ADDENDUM NO. 4
TO THE CONTRACT DOCUMENTS
for the construction of the
NAMPA WWTP PHASE I UPGRADES:
GROUP A—LIQUID STREAM UPGRADES

Date: March 6, 2015
Project No.: 480770

The following changes, additions, and/or deletions are hereby made a part of the Contract Documents for the construction of the Nampa WWTP Phase I Upgrades: Group A—Liquid Stream Upgrades, dated December 2014, as fully and completely as if the same were fully set forth therein:

AS NOTED	
VERIFY SCALE	
BAR IS ONE INCH ON ORIGINAL DRAWING.	
DATE	DECEMBER 2014
PROJ	480770
DWG	050-E-108
SHEET	54 of 157

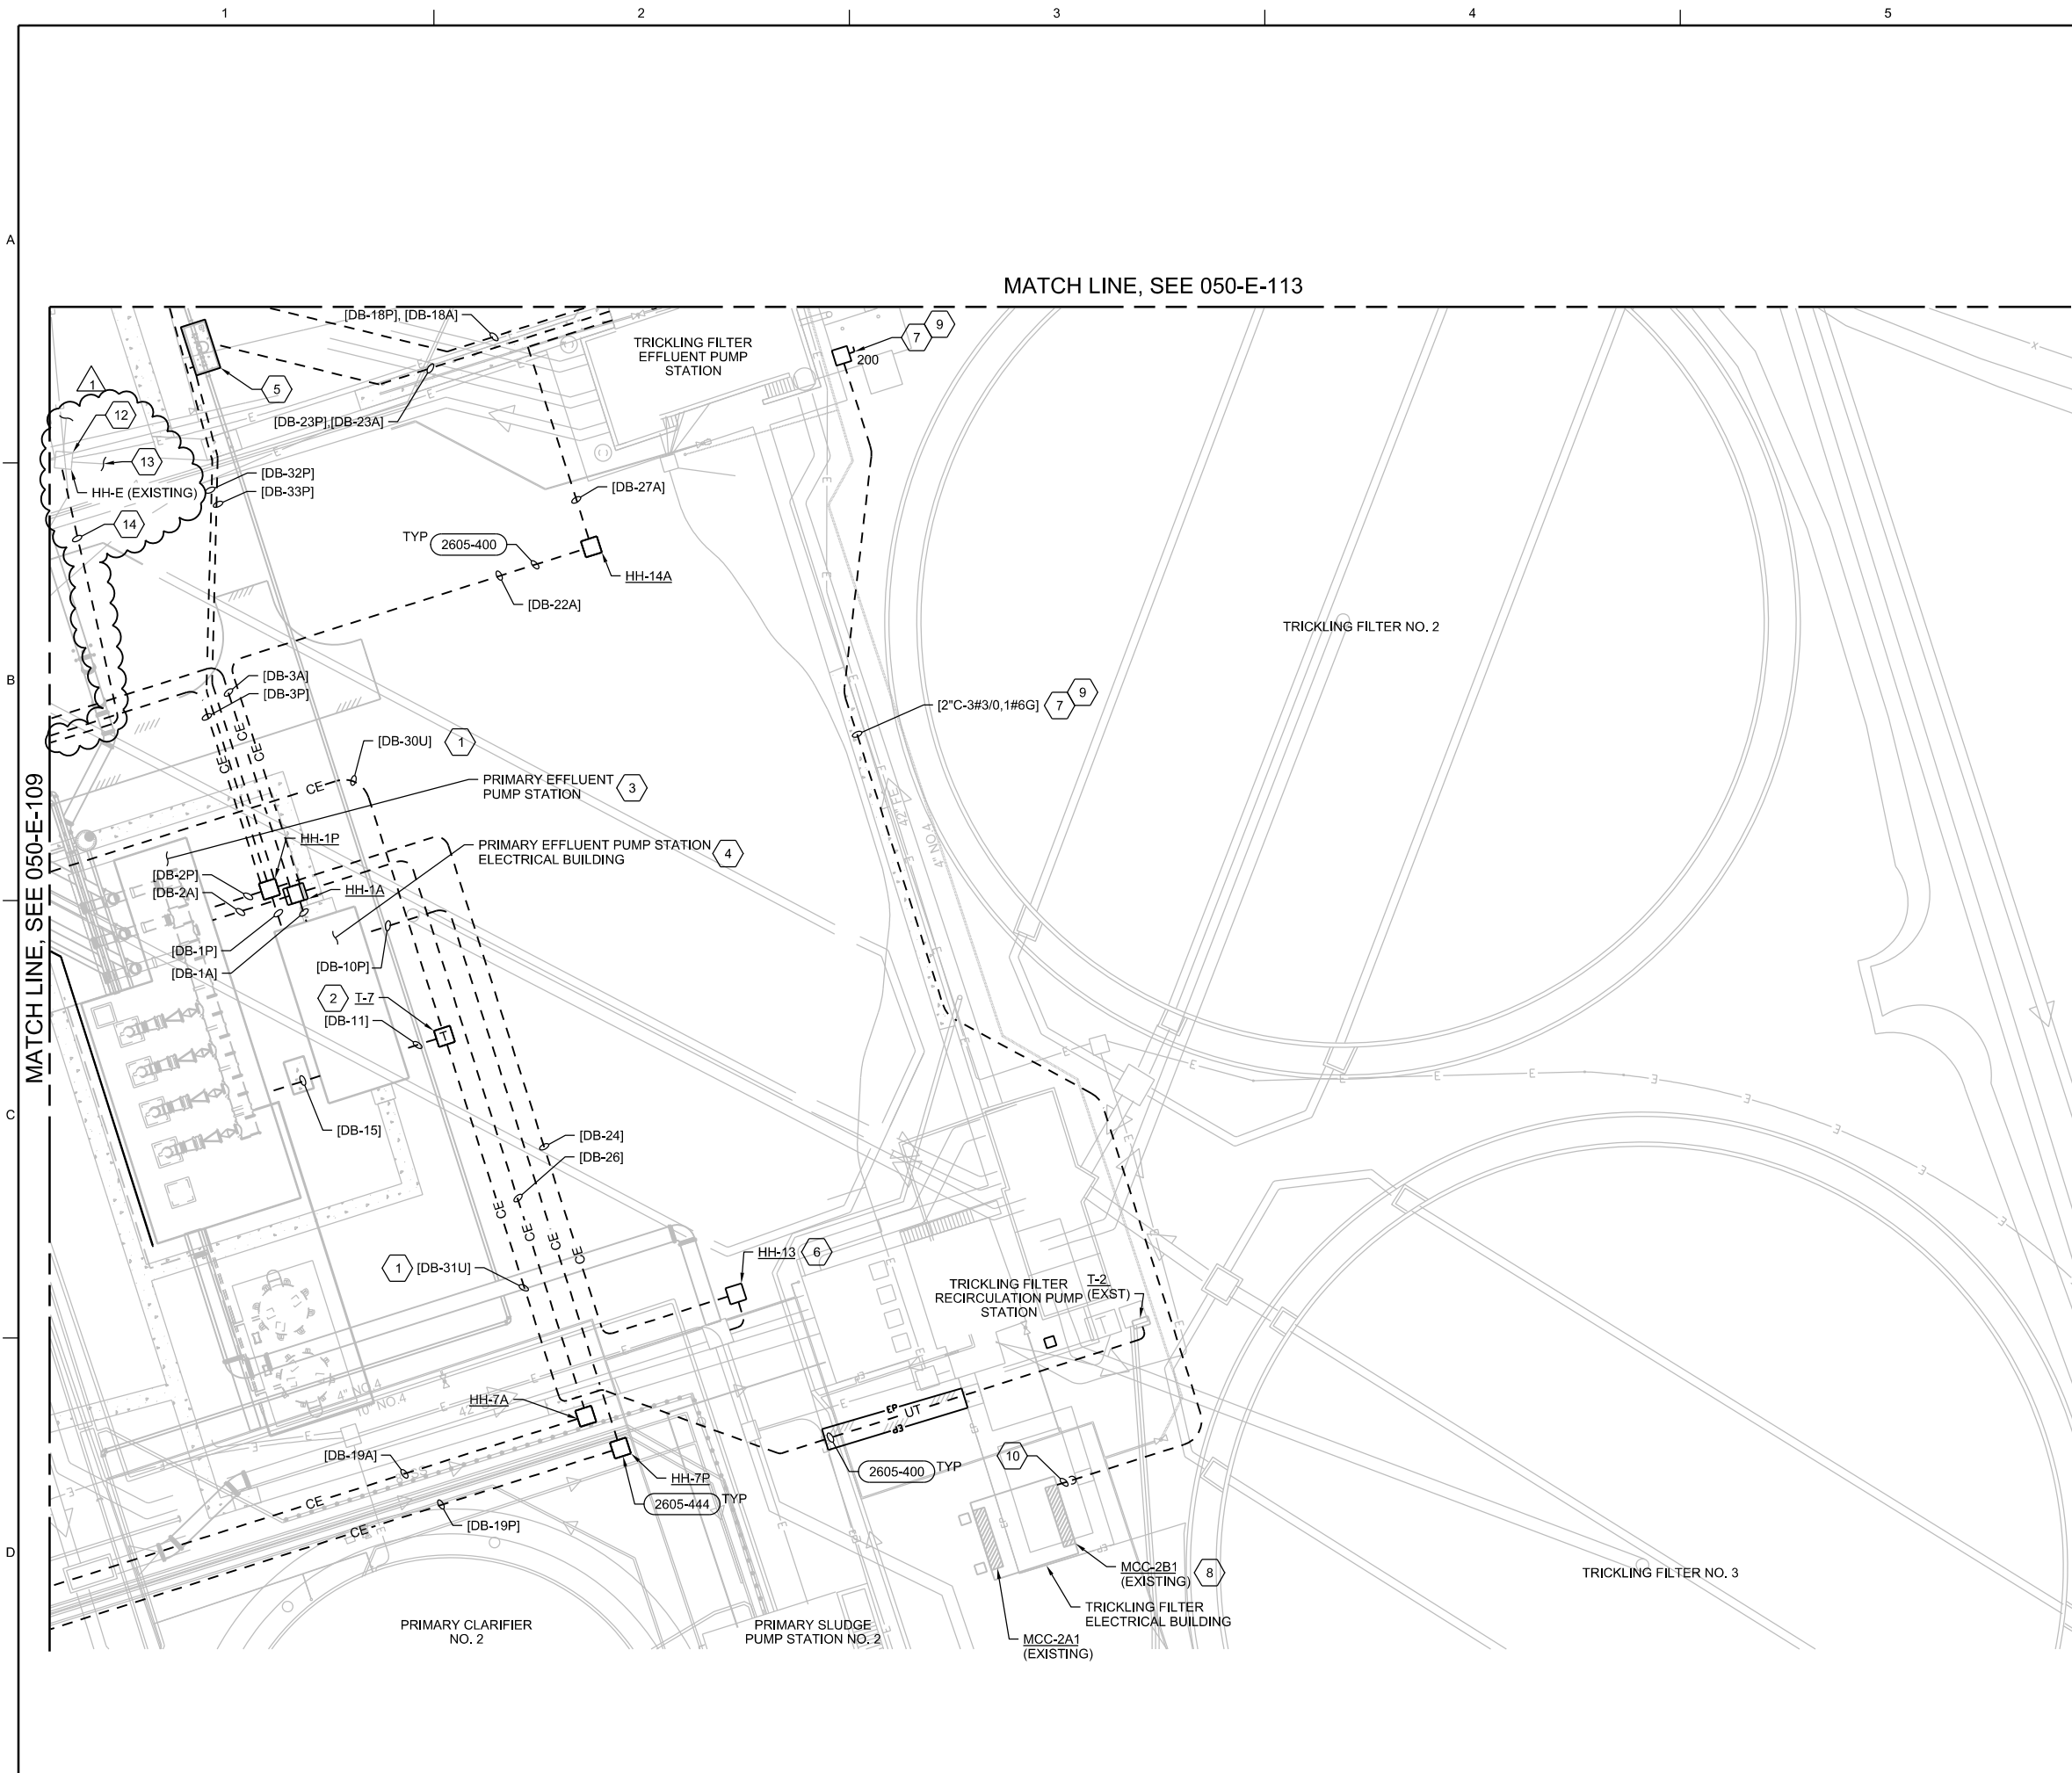
10. Drawing 050-E-103⁵: REPLACE Drawing 050-E-103 with the attached drawing.
11. Drawing 050-E-108⁶: REPLACE drawing in its entirety.
12. Drawing 050-E-109⁷: REPLACE drawing in its entirety.

AS NOTED
VERIFY SCALE
BAR IS ONE INCH ON ORIGINAL DRAWING.
DATE: DECEMBER 2014
PROJ: 480770
DWG: 423-S-111
SHEET: 137 of 157

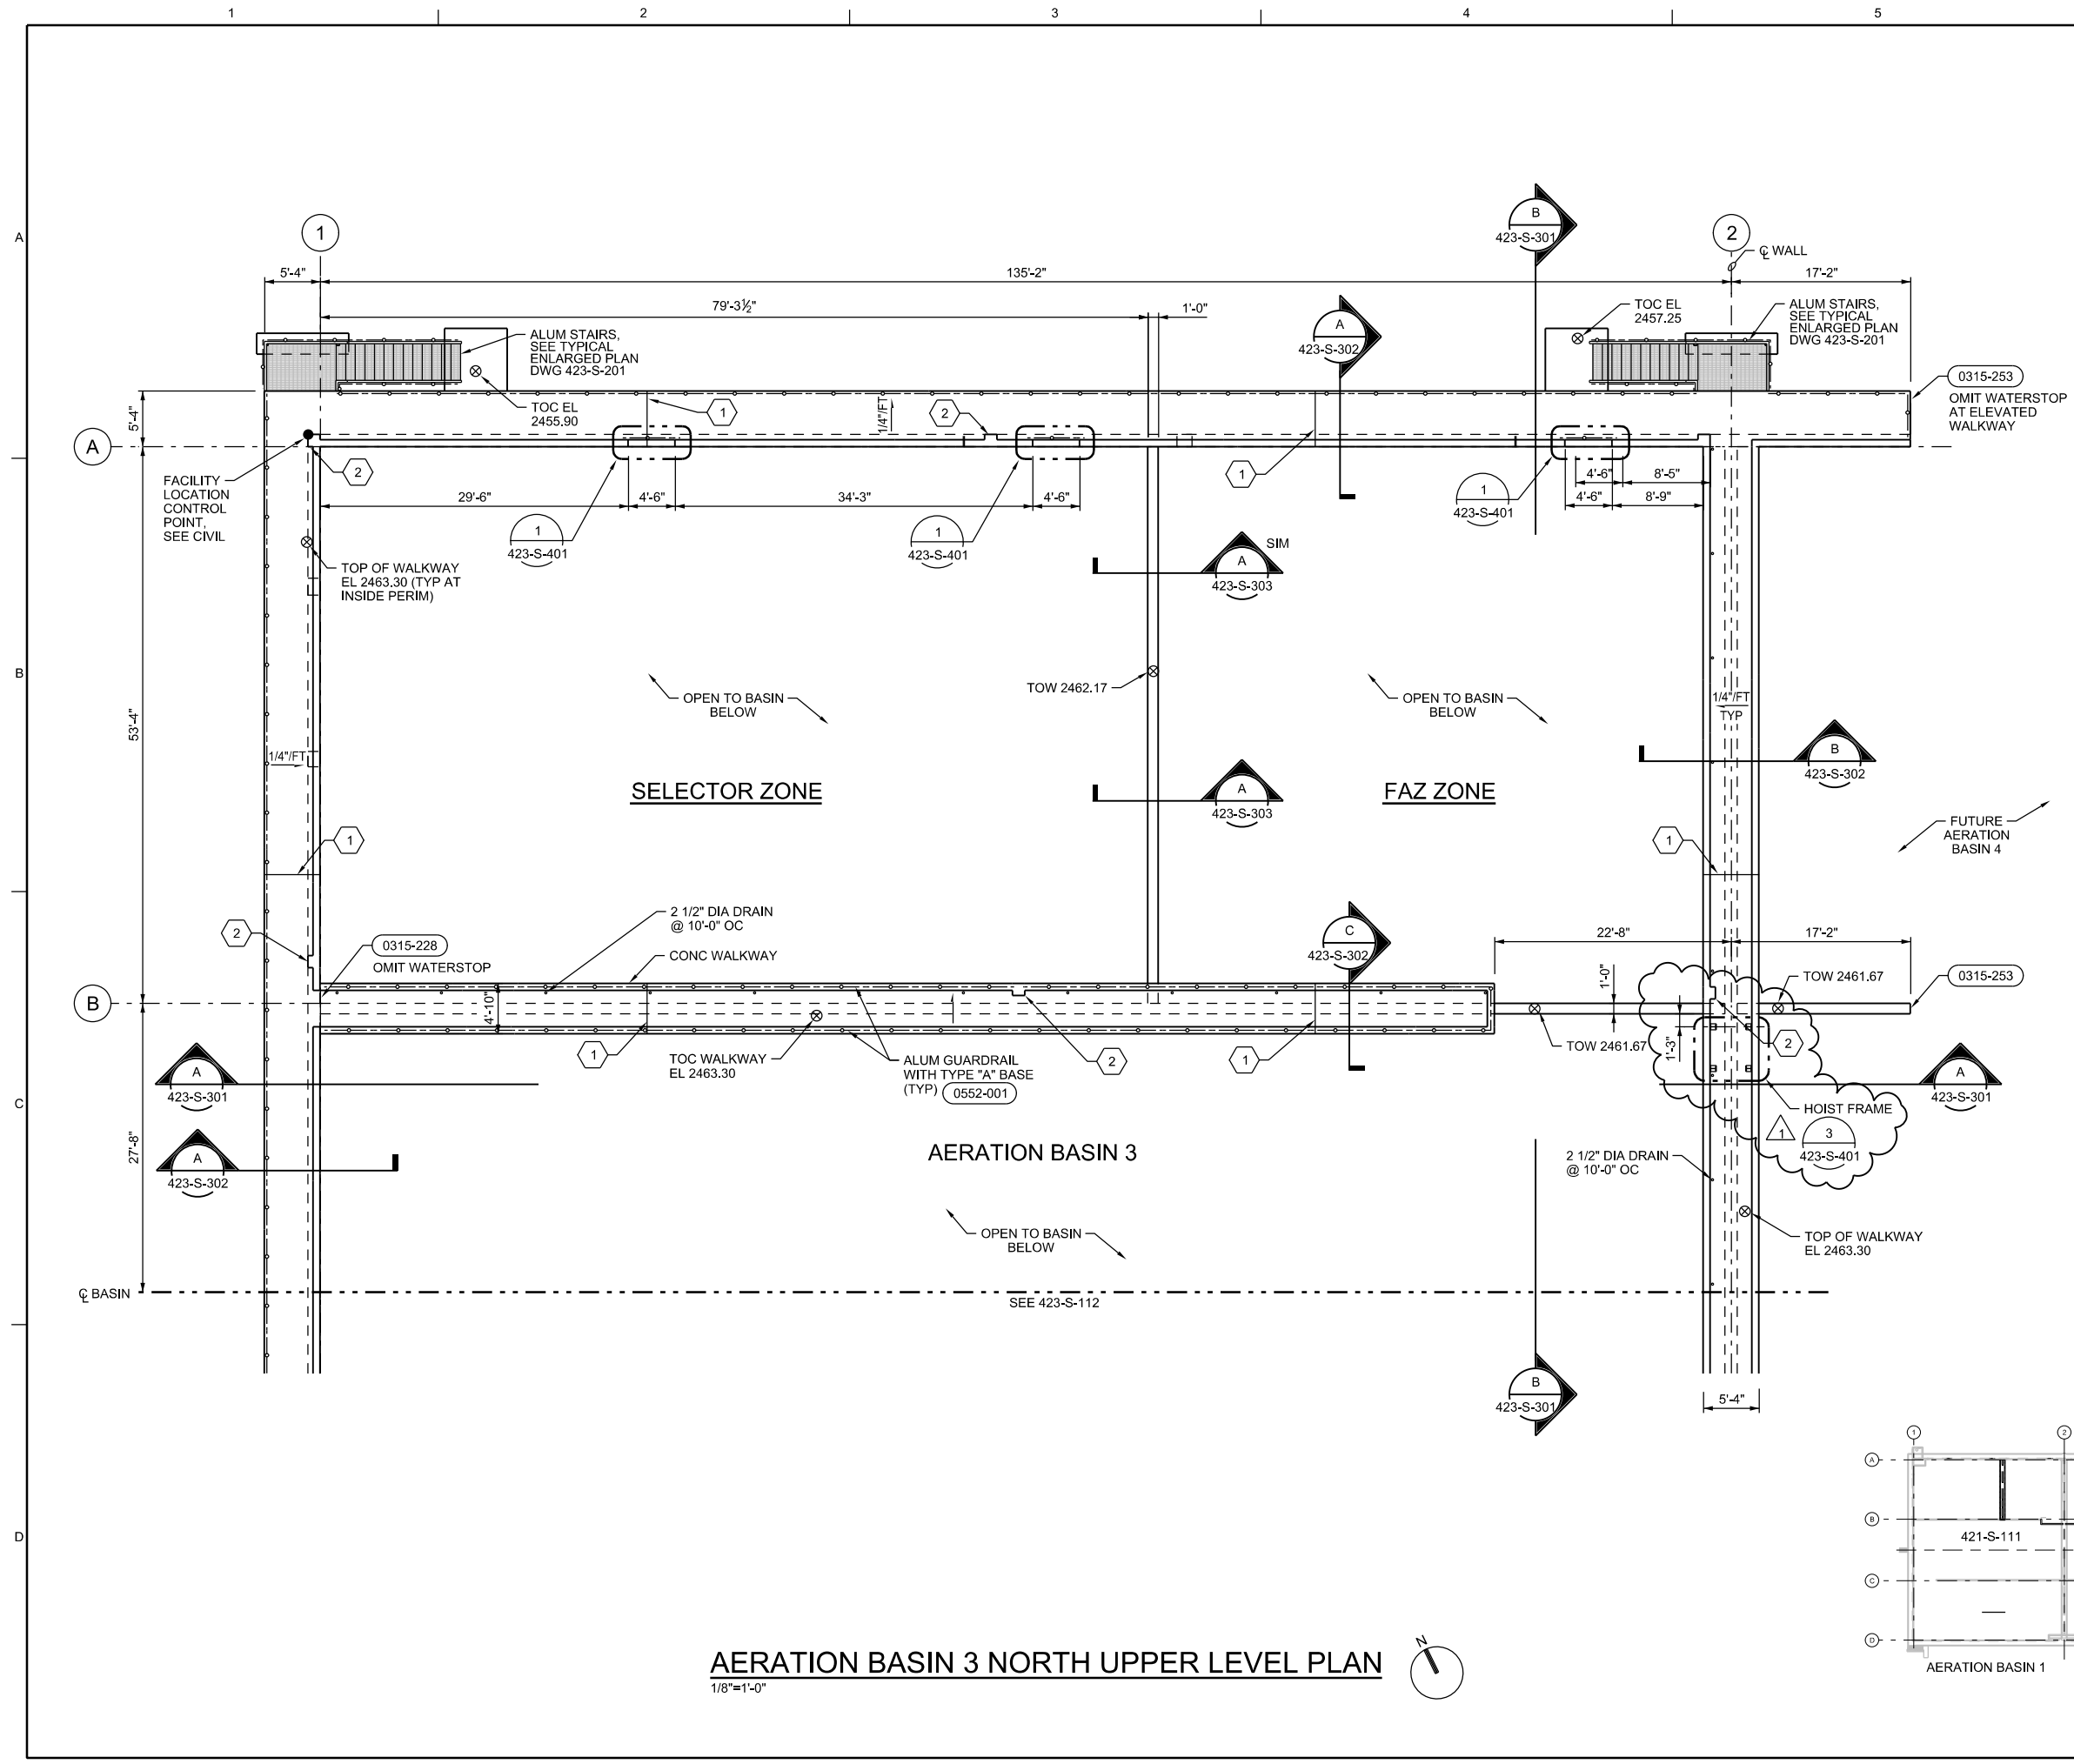
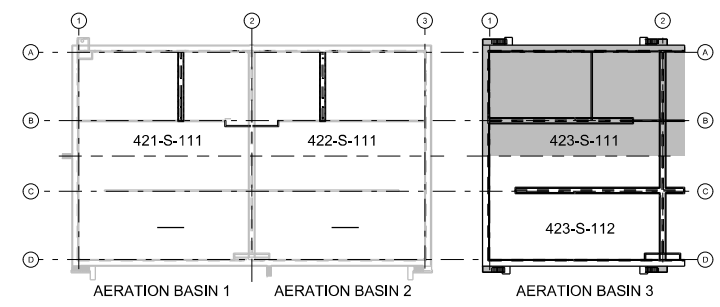
- 19. Drawing 423-S-111⁸: REPLACE drawing in its entirety.
 - 20. Drawing 423-S-301⁹: REPLACE drawing in its entirety
 - 21. Drawing 423-S-401¹⁰: REPLACE drawing in its entirety.

**ASPHALT RESTORATION AT
DOUBLE HANDHOLE**

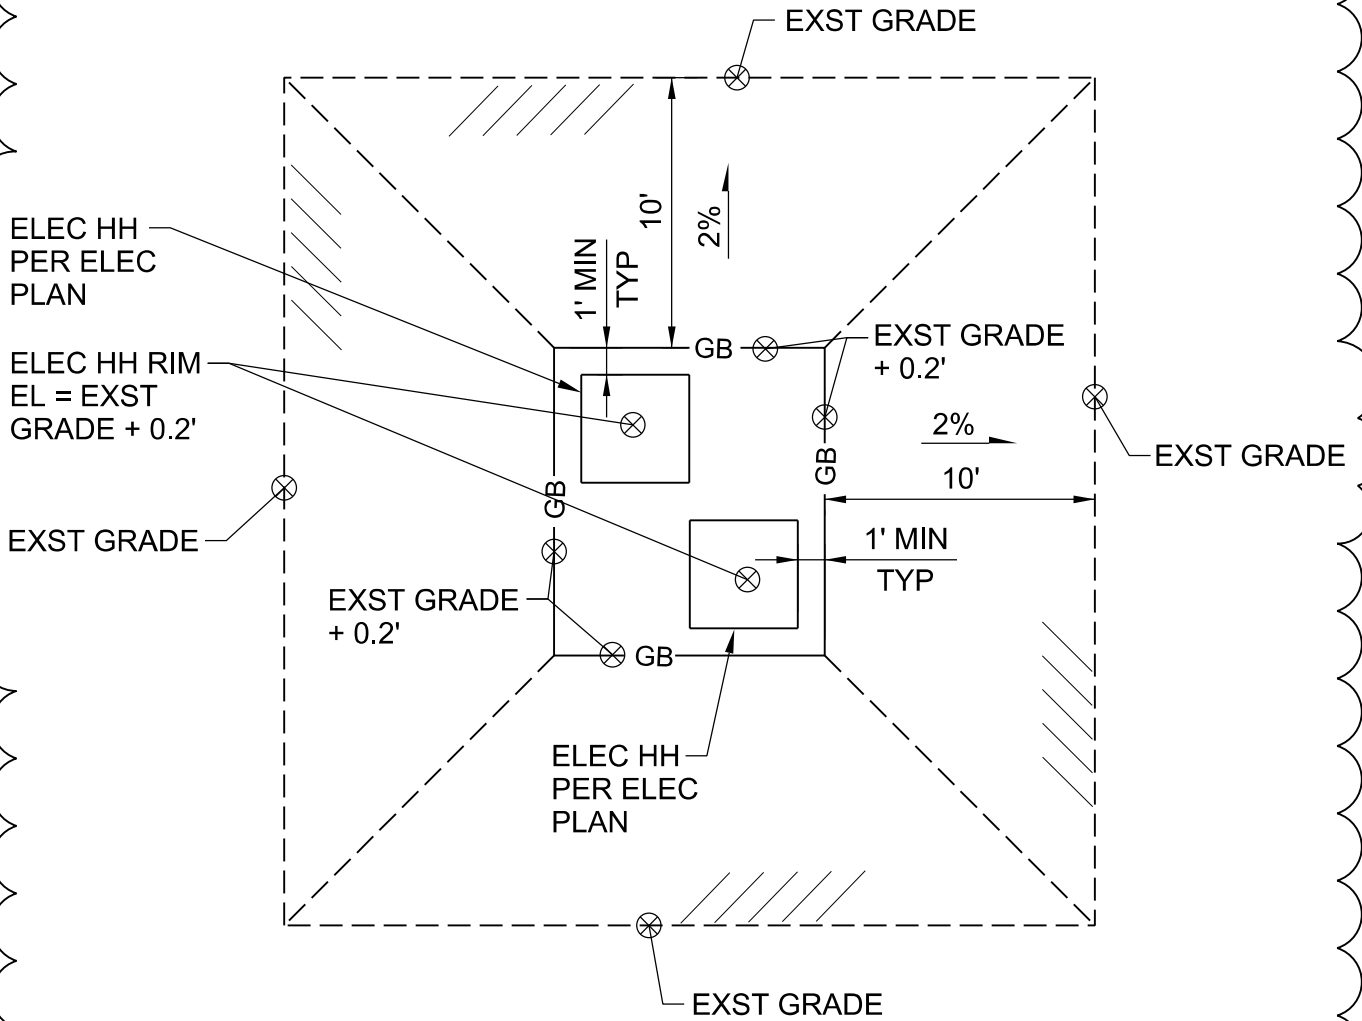
1. Design Detail 3212-212¹¹: ADD in its entirety.
